Building Field Work Requirements to Re-purpose Existing Building to Wood Shop

Building elevations and details of building areas not affected by re-purpose modifications have been eliminated.
 S.Hyder - 11/27/2023

BUILDER	B3 Contractors
CUSTOMER	Arrowhead Transfer
LOCATION	Craig, Alaska
PROJECT	Arrowhead Shop
BUILDERS PO#

South Elevation

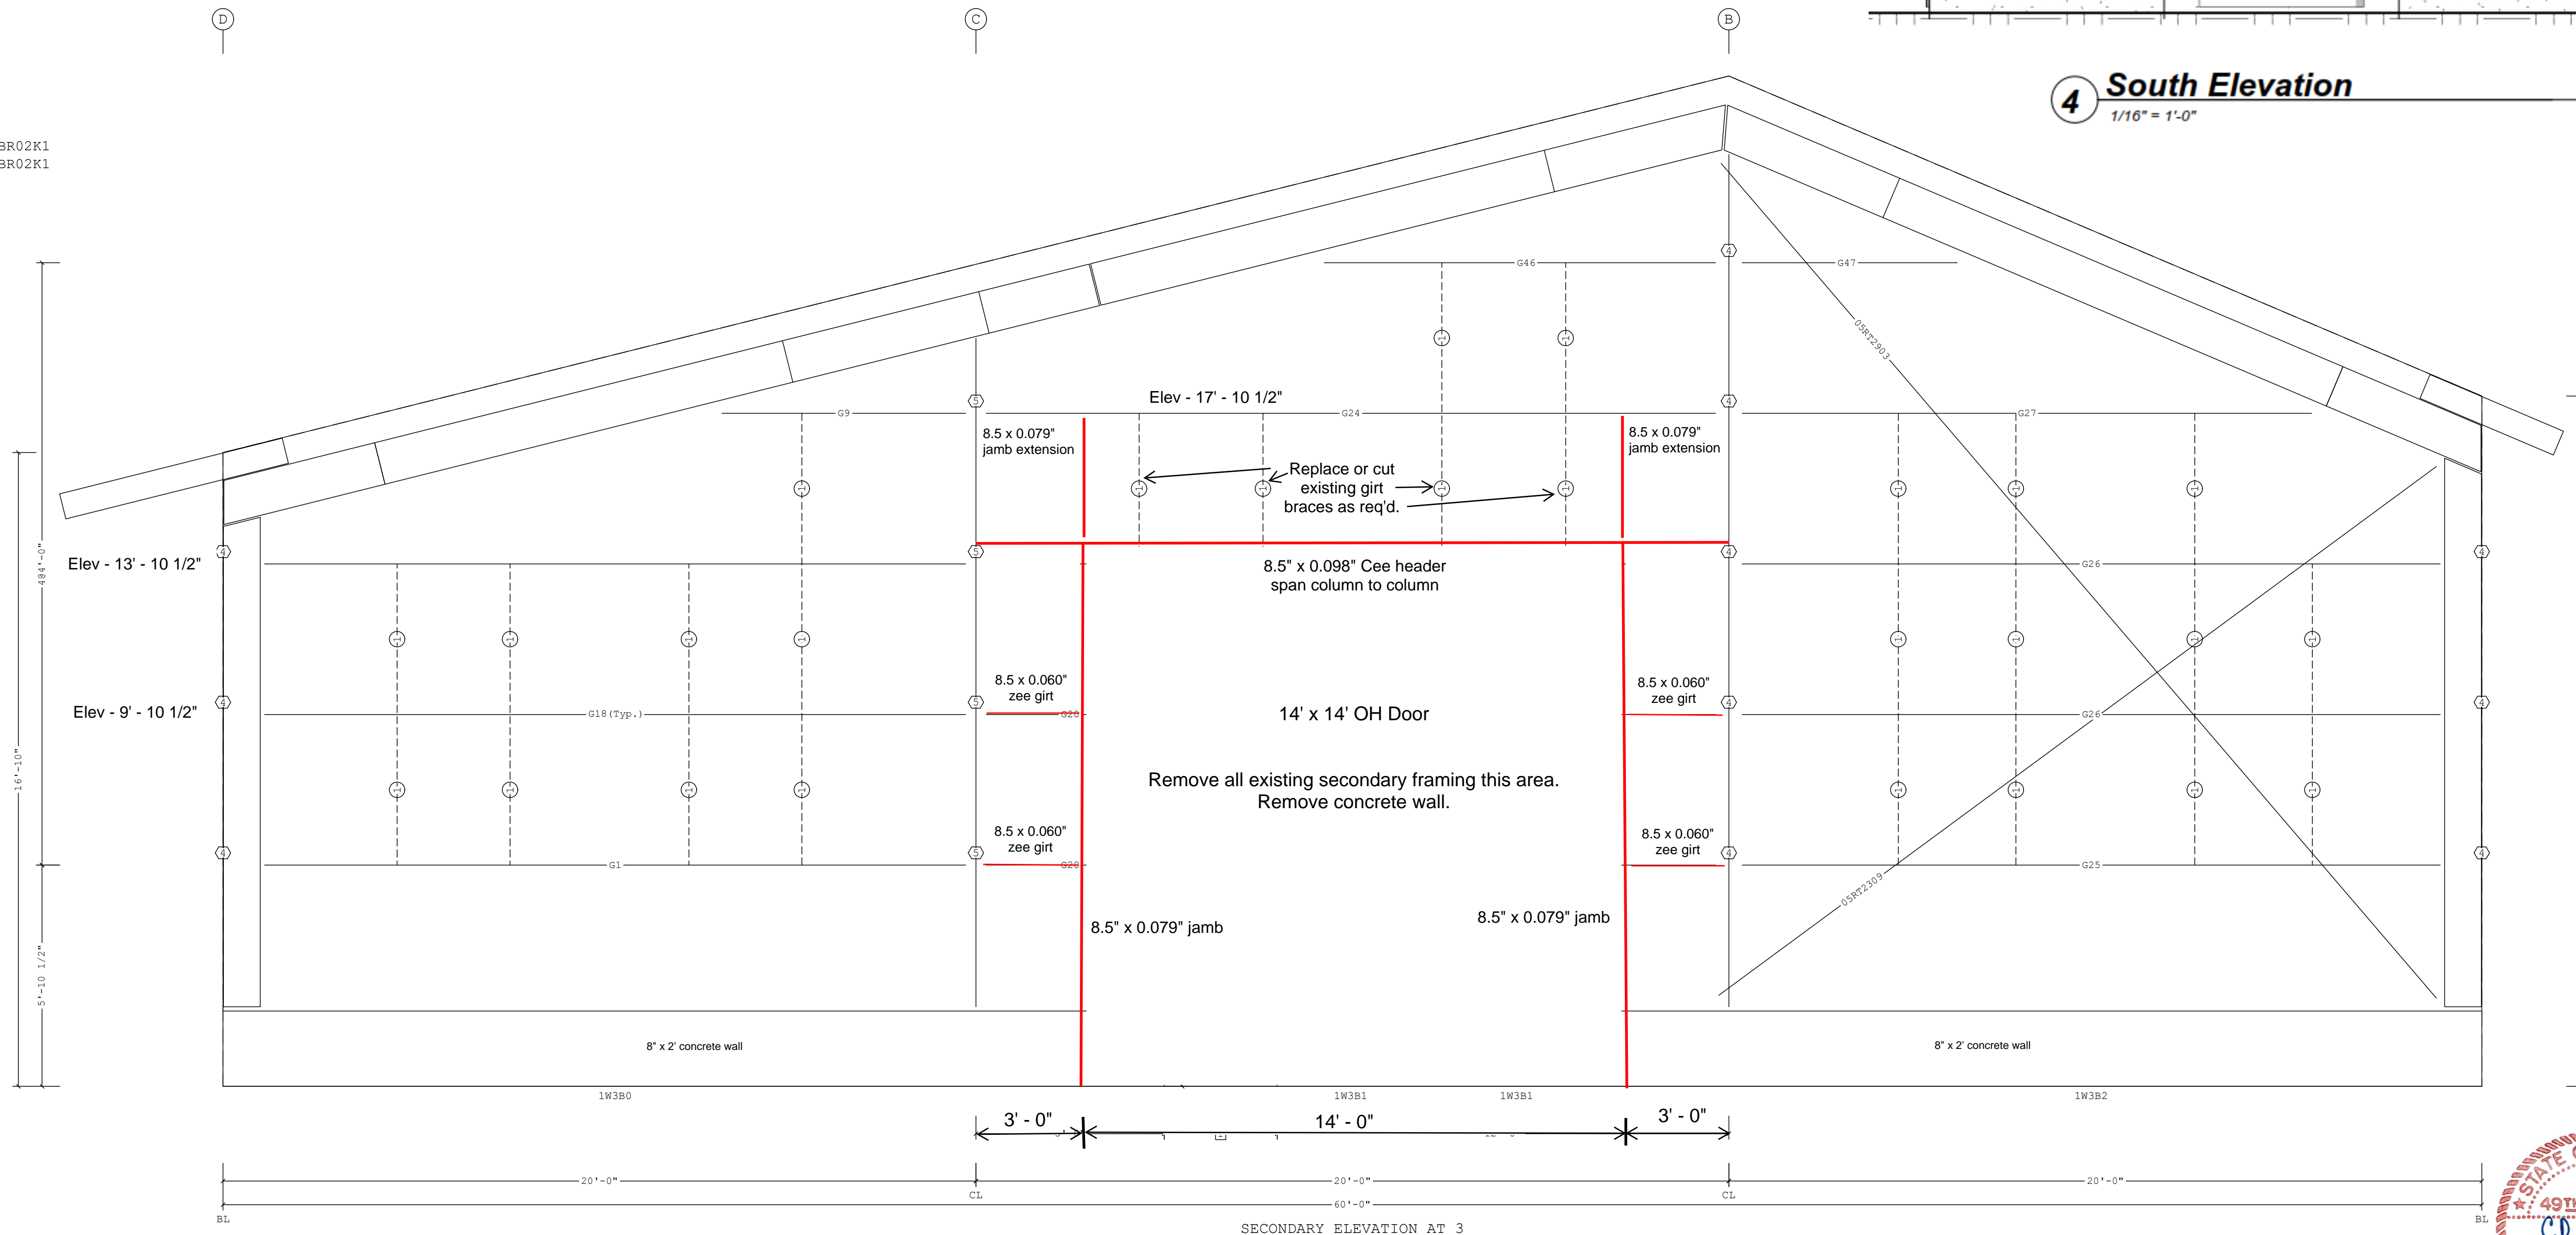
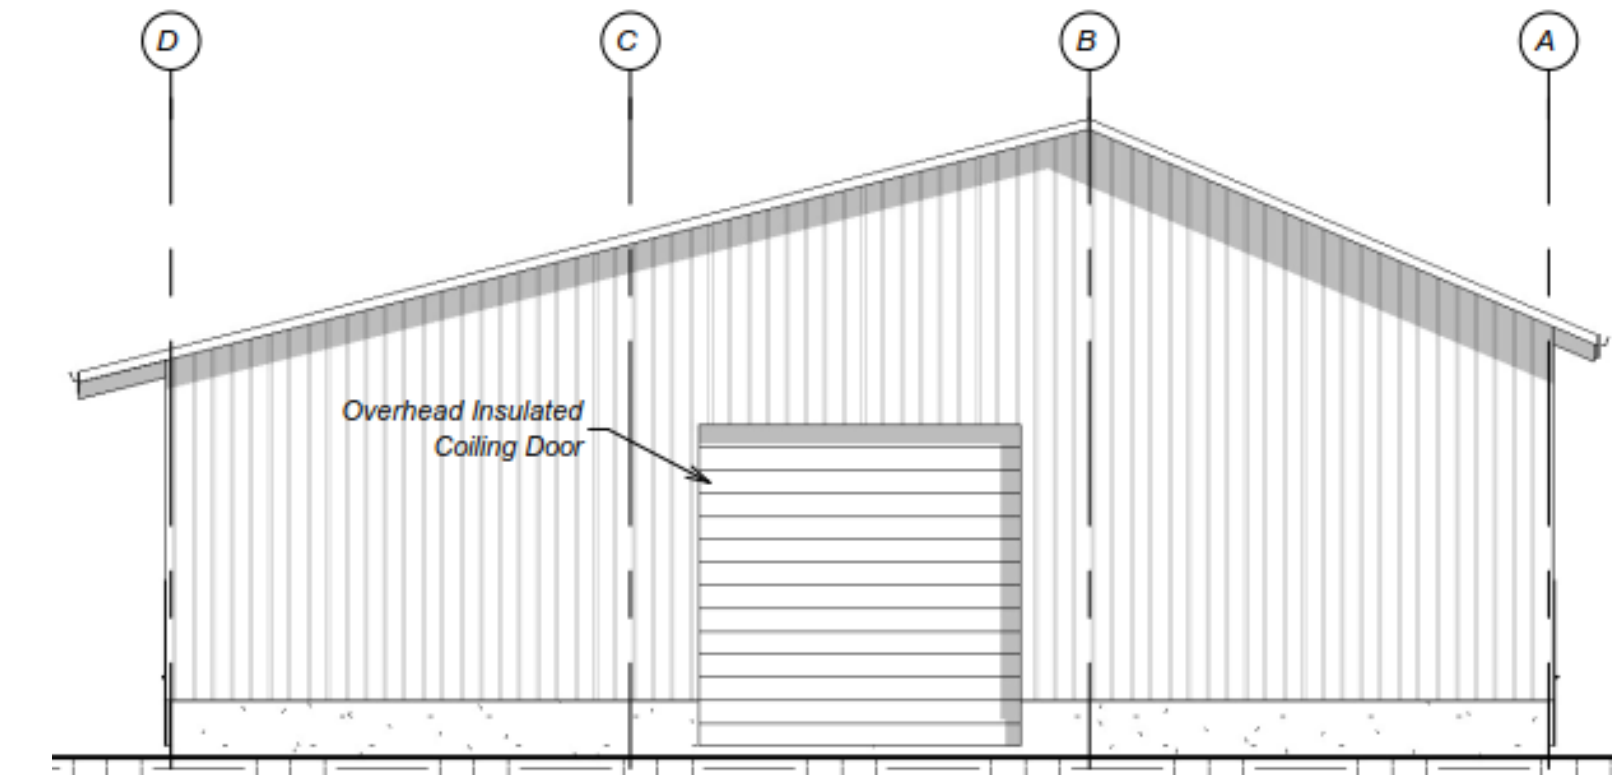
Add new KingSpan IMP panels to close in endwall.

SECONDARY ELEVATION AT D	
BUILDER	B3 Contractors
CUSTOMER	Arrowhead Transfer
LOCATION	Craig, Alaska
PROJECT	Arrowhead Shop
BUILDERS PO#

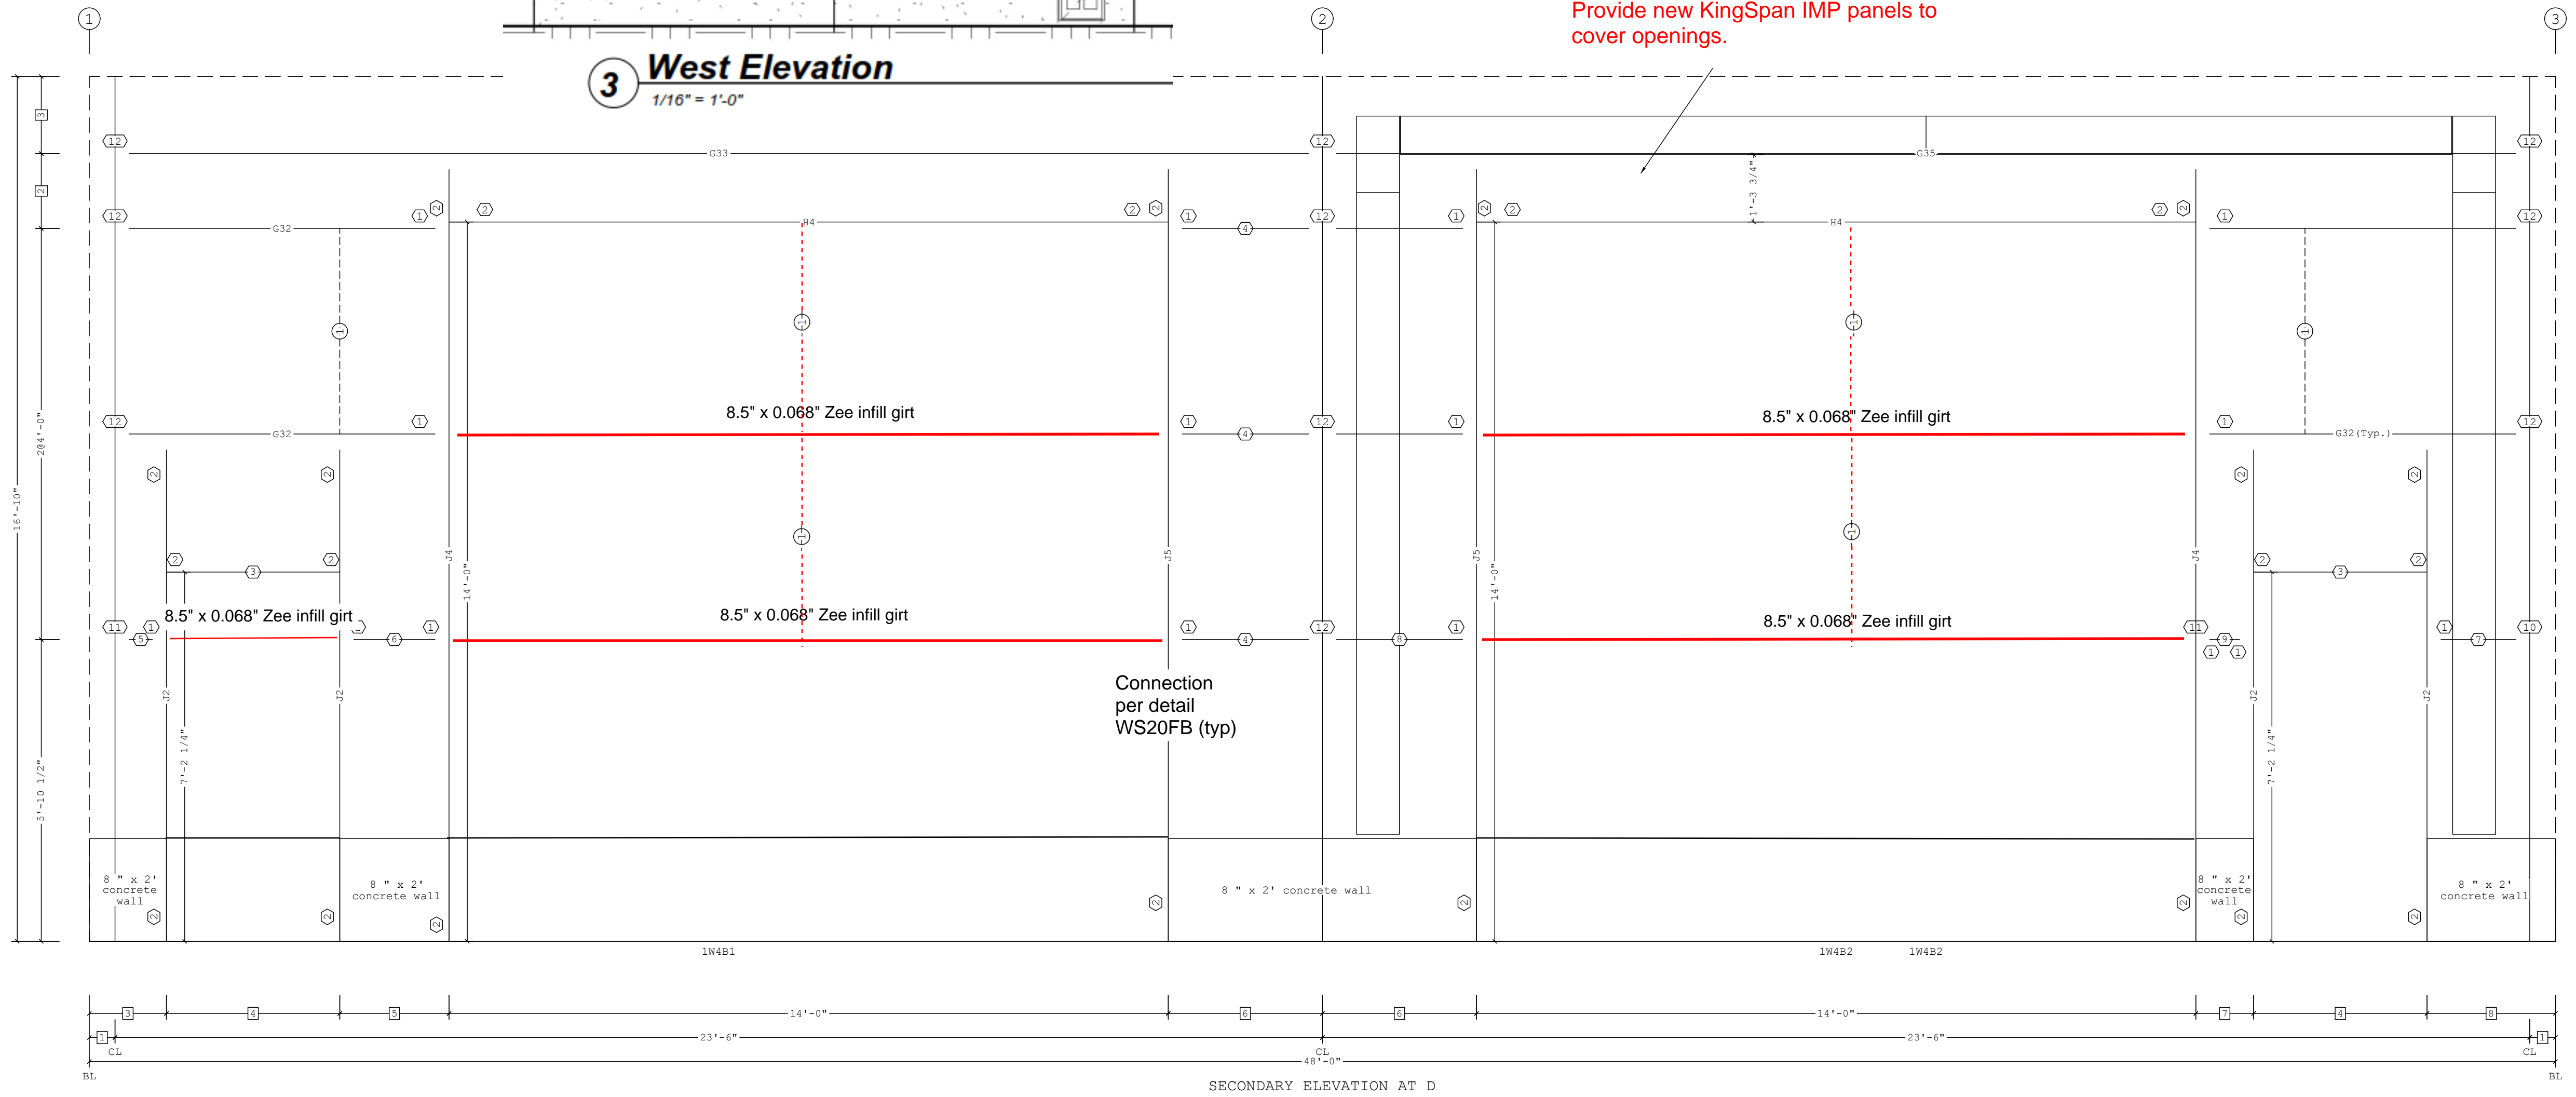
Provide new KingSpan IMP panels to cover openings.
